Origination Form
Proposed Revisions to a Standard Plans Index

| Originator: | Gibbs, Shae | Index Number: | 711-003 |
| E-mail: | shae.gibbs@dot.state.fl.us | Index Title: | Interchange Markings |

TYPICAL PAVEMENT MARKINGS AT ENTRANCE RAMPS

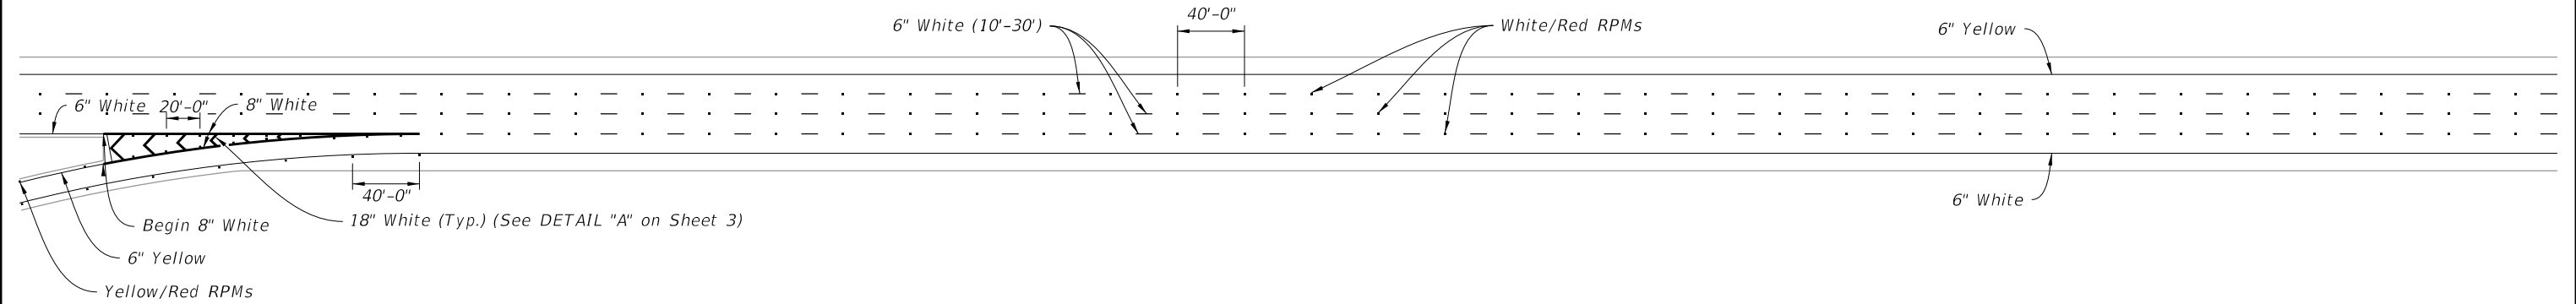
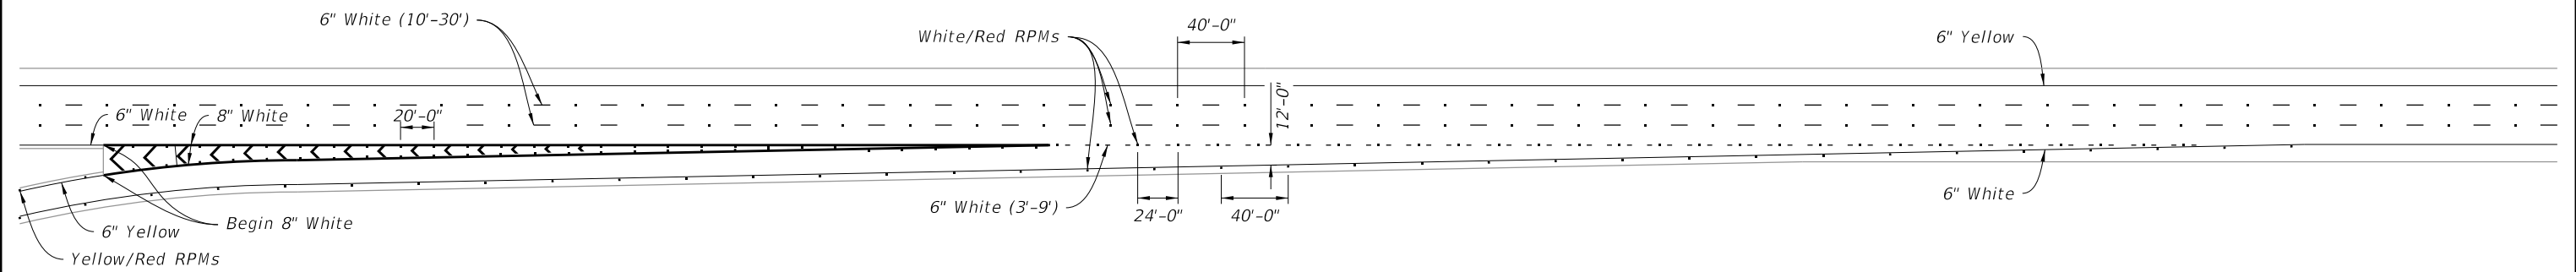
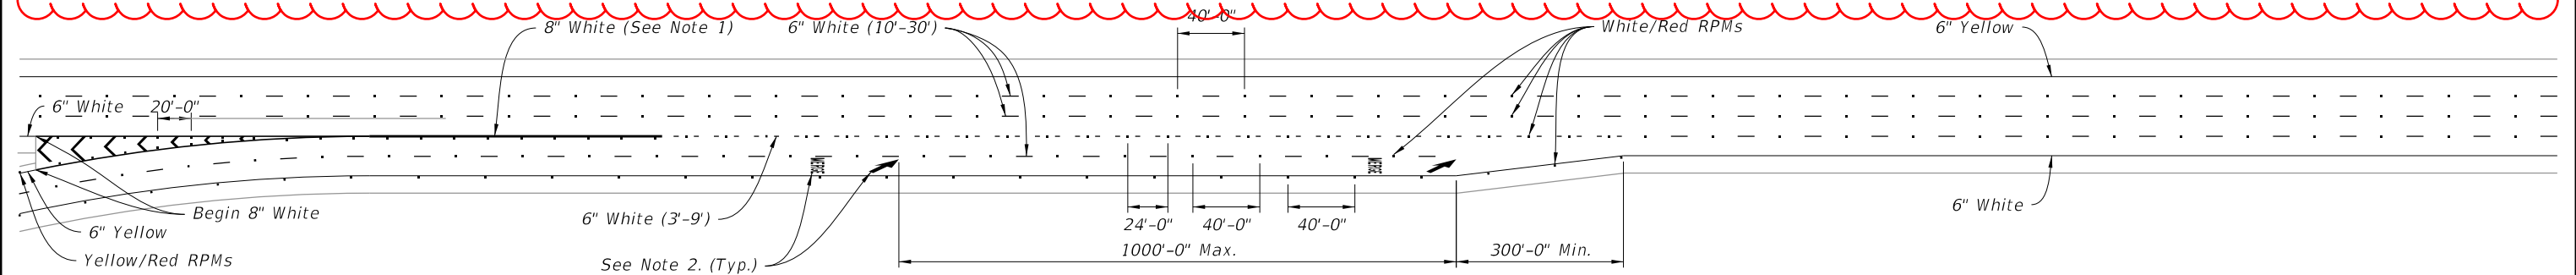
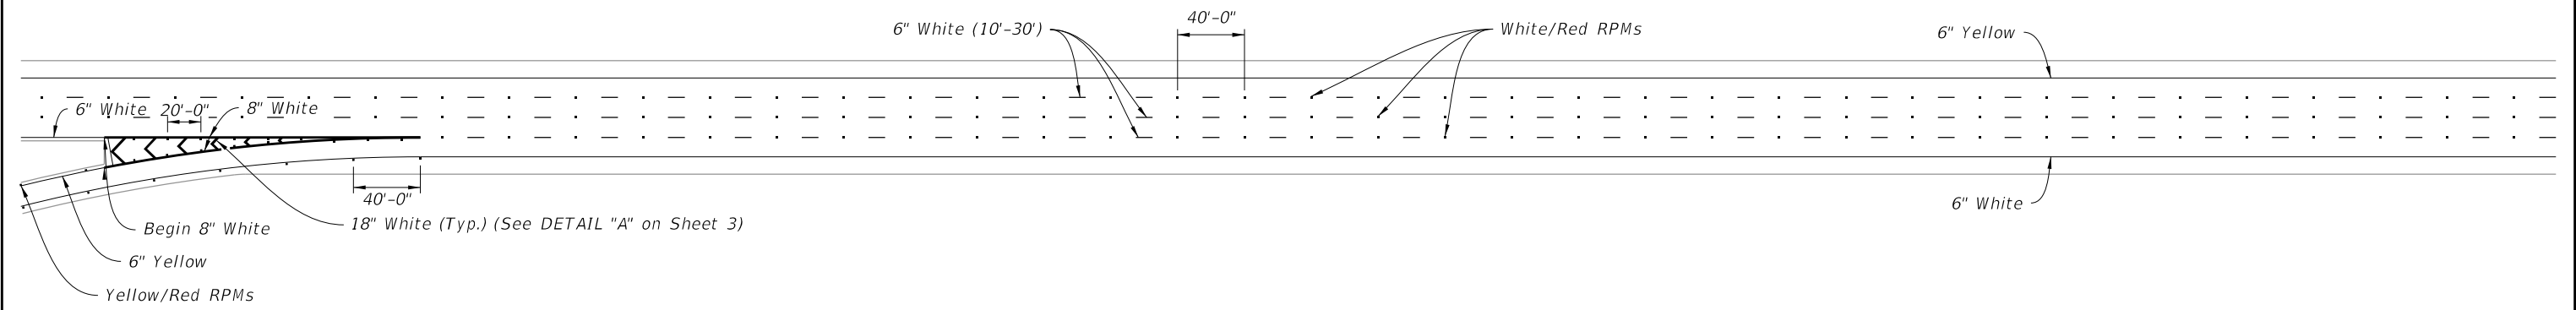
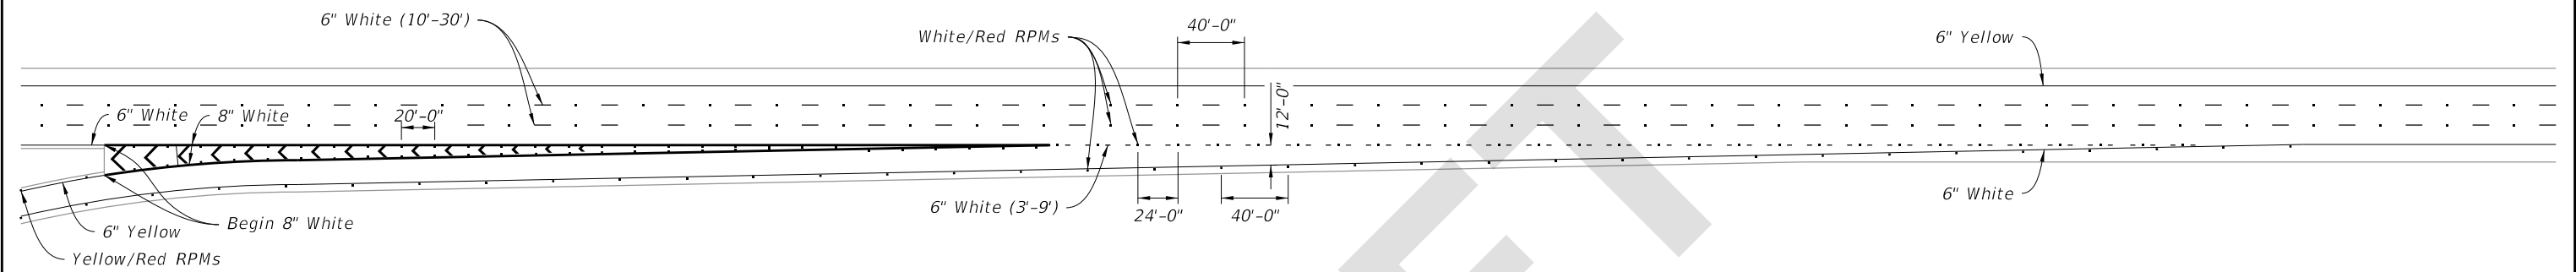
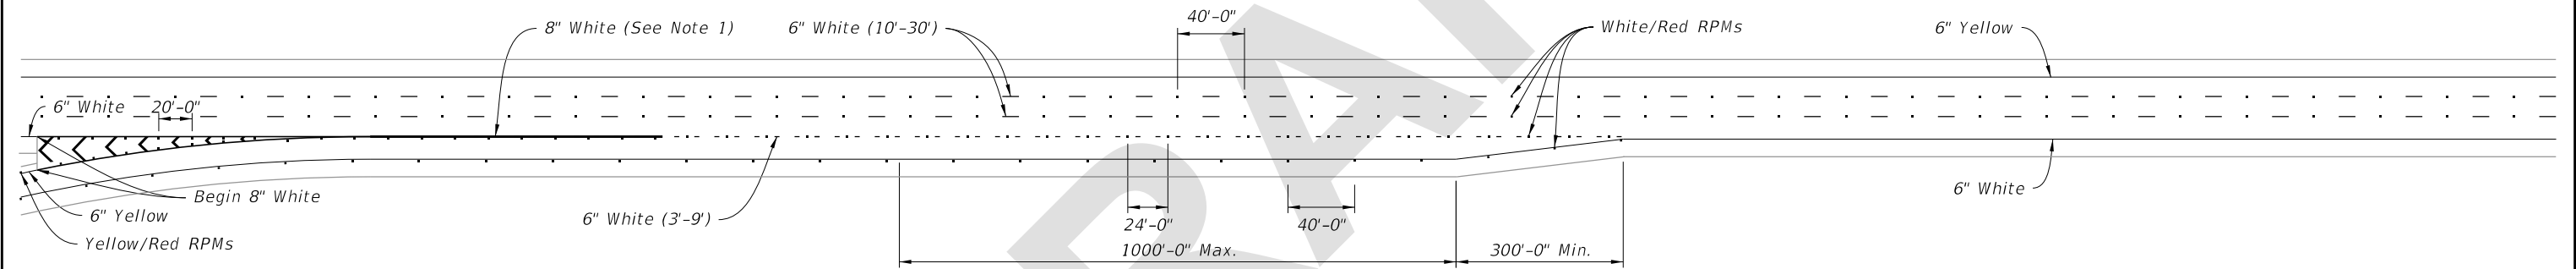
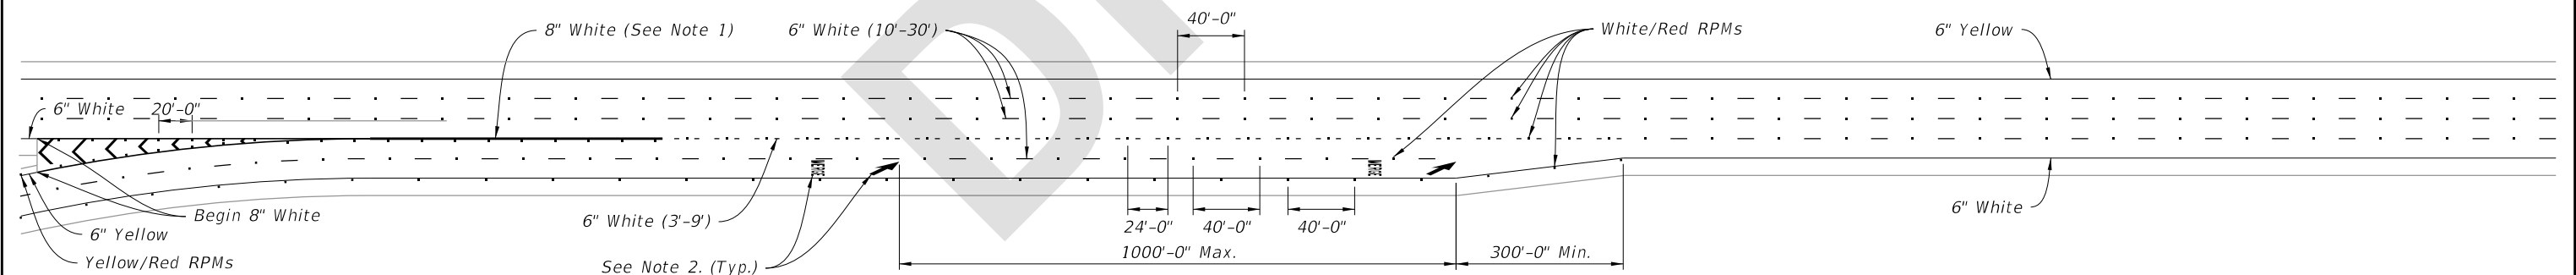
Sheet 2: Added SINGLE-LANE PARALLEL-TYPE ENTRANCE WITHOUT ADDED LANE detail.
Sheet 5: Updated wrong-way arrows to match 706-001.
Sheet 6: Updated wrong-way arrows to match 706-001.
Sheet 7: Updated wrong-way arrows to match 706-001, removed edge line markings from crosswalk areas.

Sheet 2: Due to ongoing confusion on what striping to use in Parallel-Type Entrances, a detail was added for SINGLE-LANE PARALLEL-TYPE ENTRANCE WITHOUT ADDED LANE for clarification

ADDED: SINGLE-LANE PARALLEL-TYPE ENTRANCE WITHOUT ADDED LANE detail
